BLAISE AD HAZOP

RMD-02-004

An interface HAZOP study was undertaken at BioConstruct's offices at Stockton-on-Tees, Teesside on 3rd June 2019, commencing on 4th June and being completed on 9th July, on the design of the proposed Anaerobic Digestion Facility for Crofthead.

This report details the findings of the HAZOP Study. The drawings used in the HAZOP study are found in the Drawings Section of this report and are based upon the following P&IDs:

Node 3

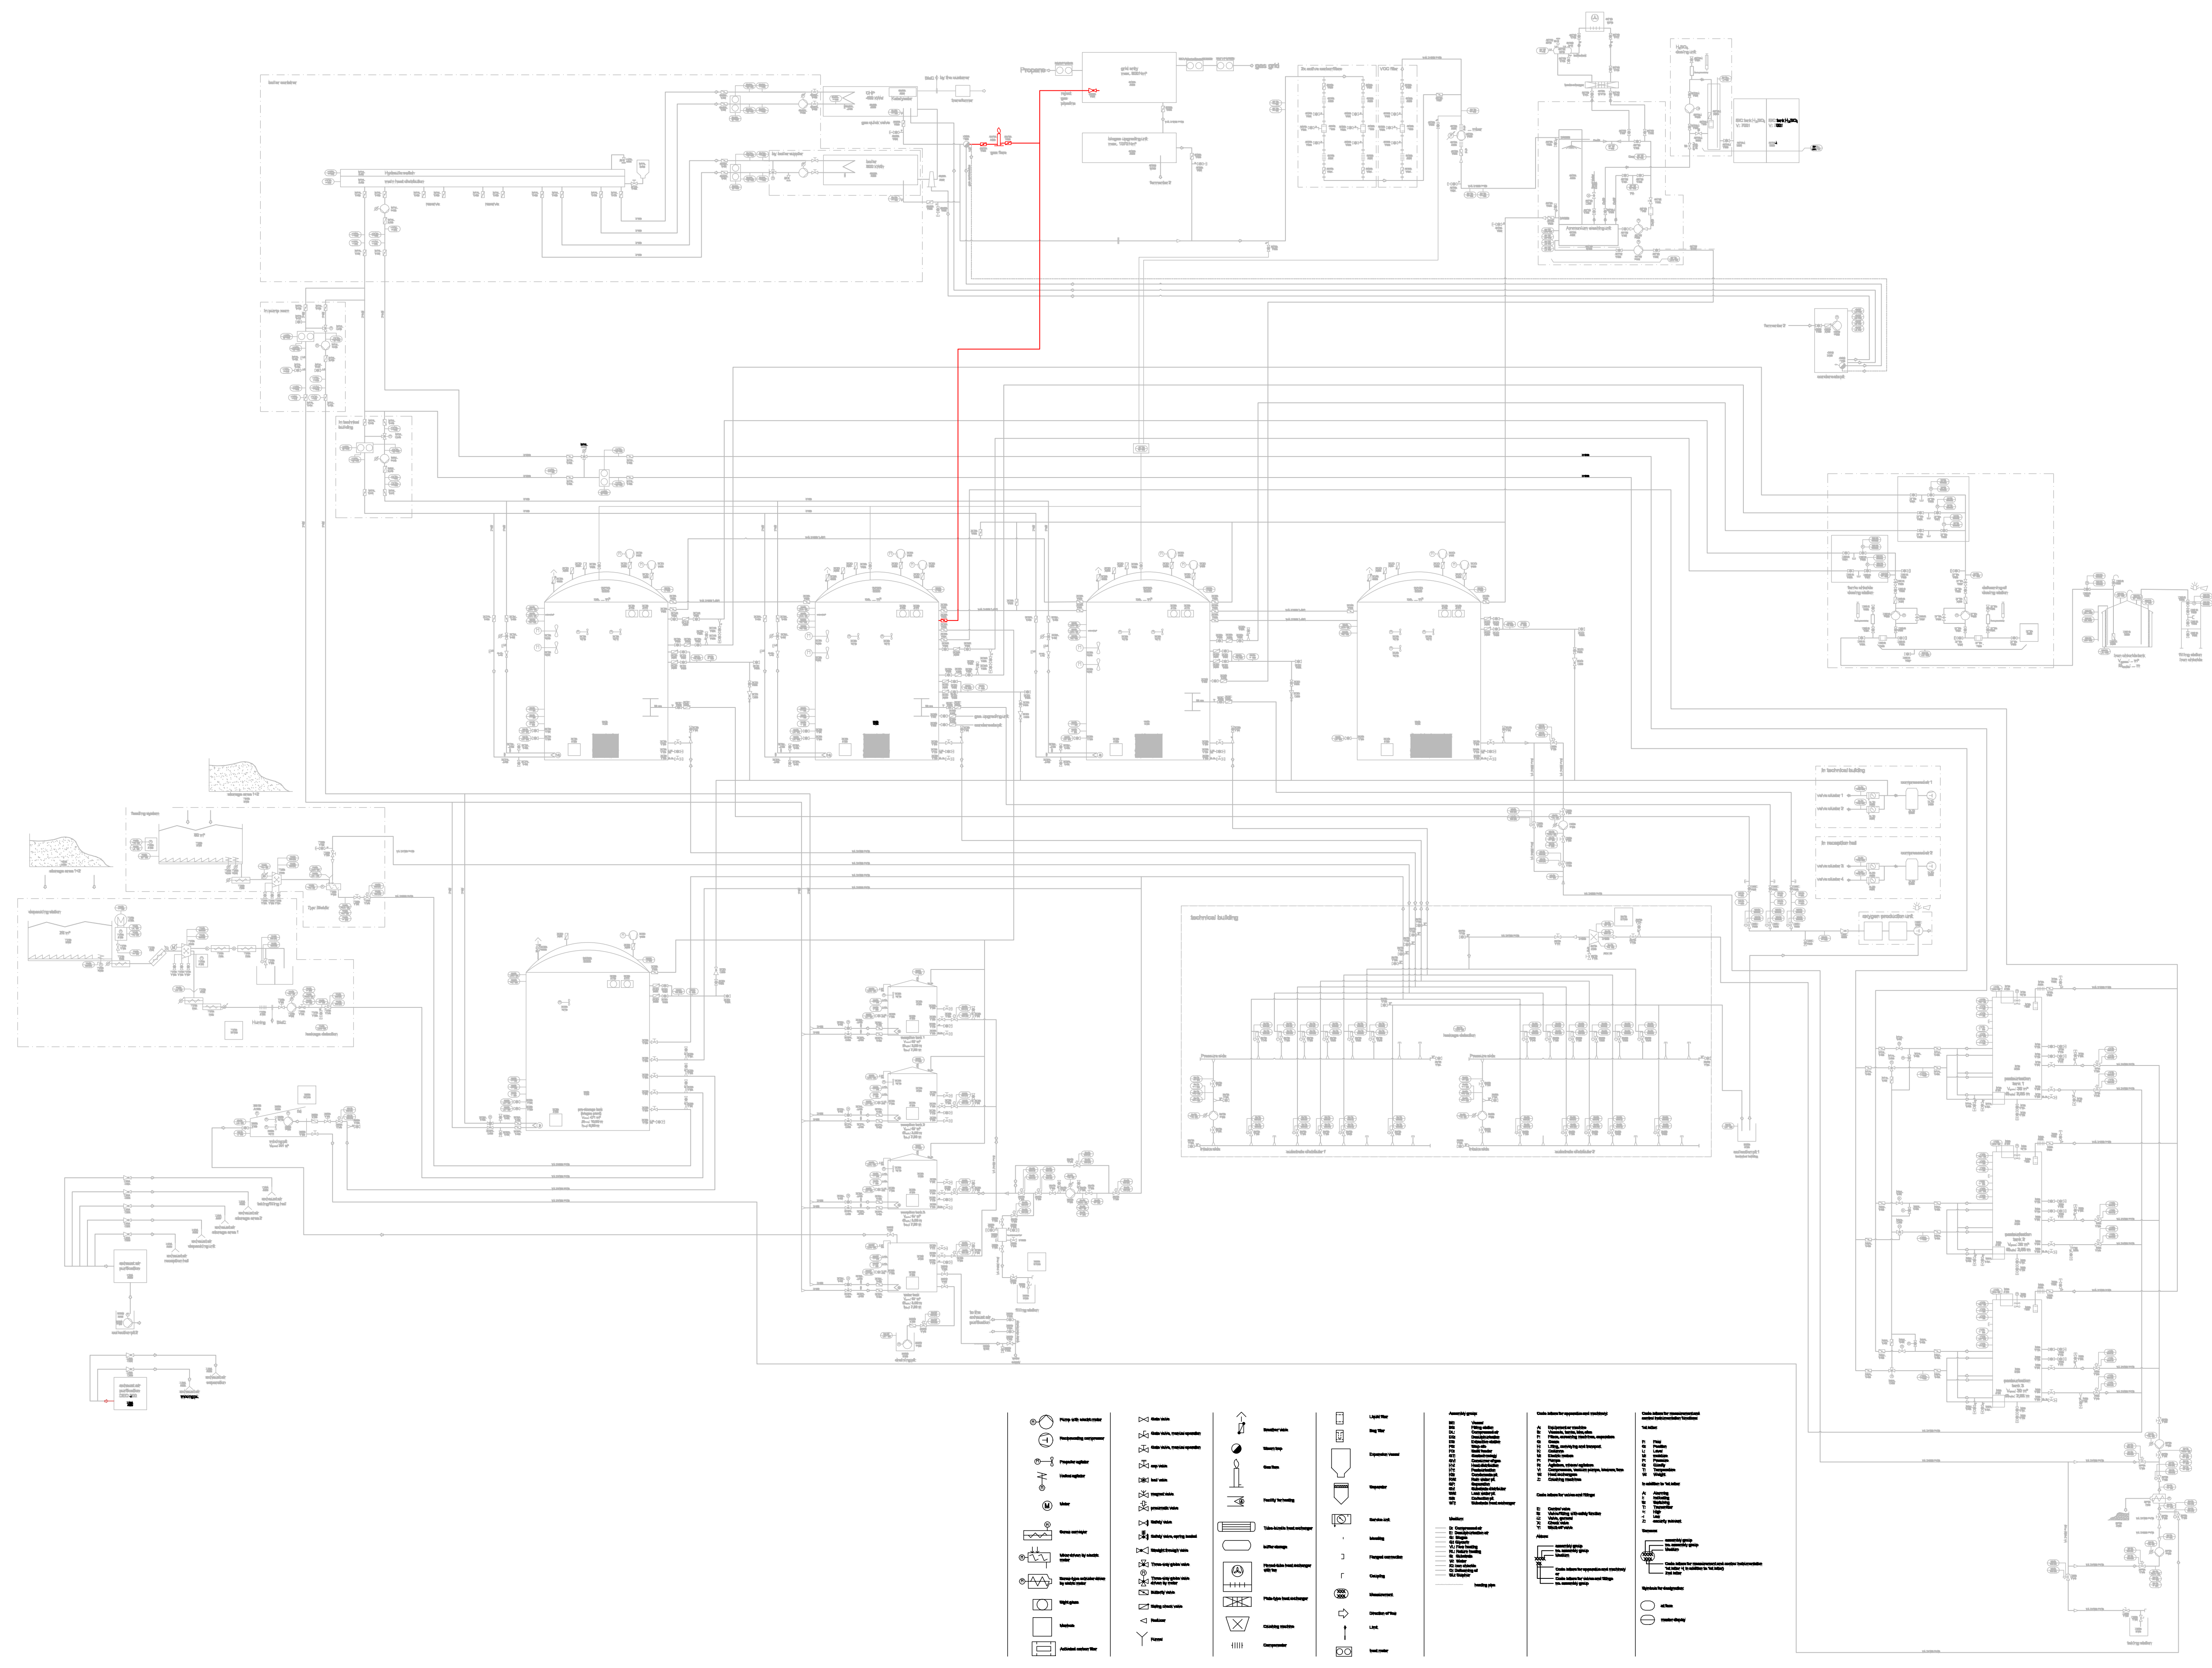
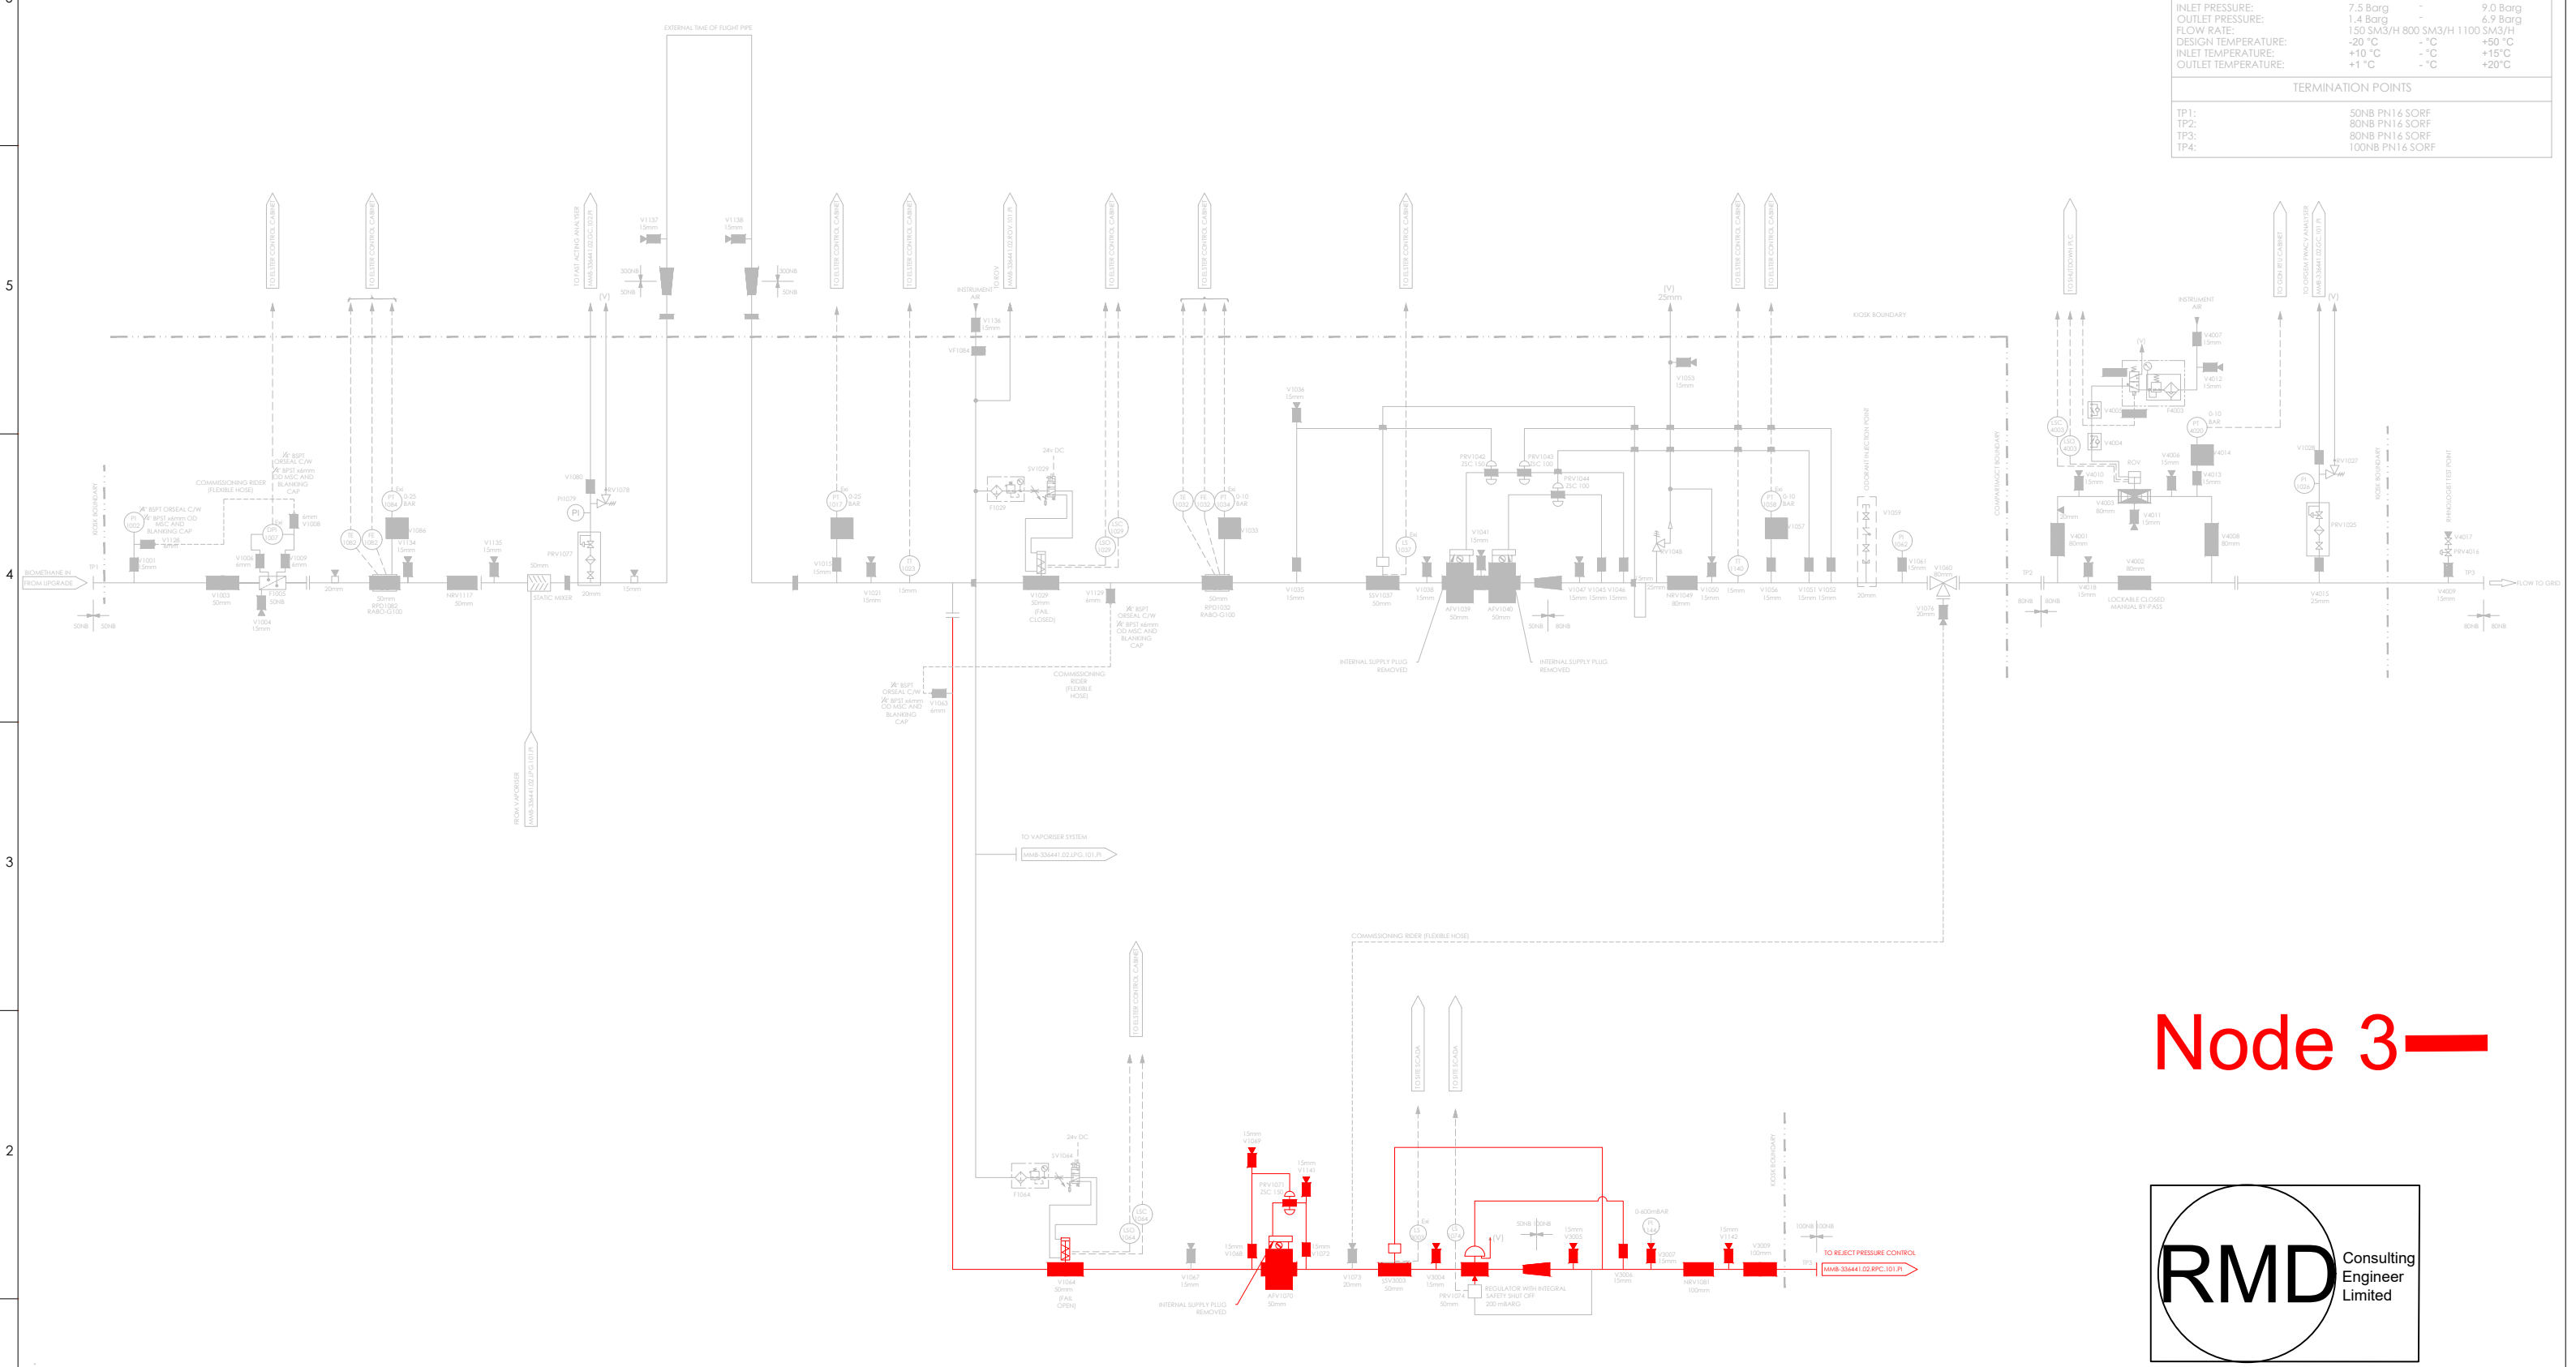
| ID/No. | Deviation | | No. | Possible Causes | Consequence | Safeguards | No. | Actions Required | Action Allocated to |
|--------|----------------|-------------|-------|---|---|--|---------|---|---------------------|
| 3.1 | As Well As | Flow | 3.1.1 | Requirement to flare from both GEU reject as well as biogas plant | • Inability to burn biomethane and biogas at same time - potential to over-pressurise the biogas system, increased fire and explosion risk, overpressure potential within GEU and BUU increased fire and explosion risk | | | | |
| 3.5 | More | Pressure | 3.5.1 | Motorised valve PBV2 / PBV0 not opening quick enough | • Potential to over-pressurise GEU increased fire and explosion risk | • Slamshut valve SSV3003 and integral safety shutoff within regular valve PRV1074 protects pipeline | | | |
| 3.6 | No | Flow | 3.6.1 | No flow of biomethane to flare - failure of internal motorised valves within flare or manual valve GV1G Y301 (operator / maintenance / commissioning error) | • Inability to flare biomethane potential increased fire and explosion risk | • Operator training • Regular maintenance and inspection • Pre-commissioning and post maintenance checks | 3.6.1.1 | On inability to flare biomethane for any reason ensure motorised valve to be installed on reject to fermenter 2 will open rapidly | BioConstruct |
| 3.8 | More | Composition | 3.8.1 | Reject of enriched biomethane to fermenter 2 | • Enriched biogas within biogas system - potential for CHP failure • Potential for over enriched feed to the Pentair unit - constant reject • Potential over enriched biogas to flare - potential damage to flare or inability to flare | • Maximum time for reject before shut down signal occurs is 20 minutes • Biogas quality (methane concentration) agreed for feed to Pentair unit | | | |

| ID/No. | Deviation | | No. | Possible Causes | Consequence | Safeguards | No. | Actions Required | Action Allocated to |
|--------|----------------|-------------|-------|---|---|--|---------|---|---------------------|
| 3.2 | General Action | | | | | | 3.2.1.1 | Remove pressure regulating valve GV6G Y301 due to Elster unit having PRV 1074 | BioConstruct |
| 3.3 | General Action | | | | | | 3.3.1.1 | To install a motorised valve in the reject line to fermenter 2 | BioConstruct |
| 3.4 | General Action | | | | | | 3.4.1.1 | Prioritise reject to flare over reject to fermenter 2 from GEU and prioritise reject from GEU over flaring from the AD plant | BioConstruct |
| 3.7 | General Action | | | | | | 3.7.1.1 | If the flare does not ignite and "goes to dump" ensure that reject to fermenter 2 can occur rapidly | BioConstruct |
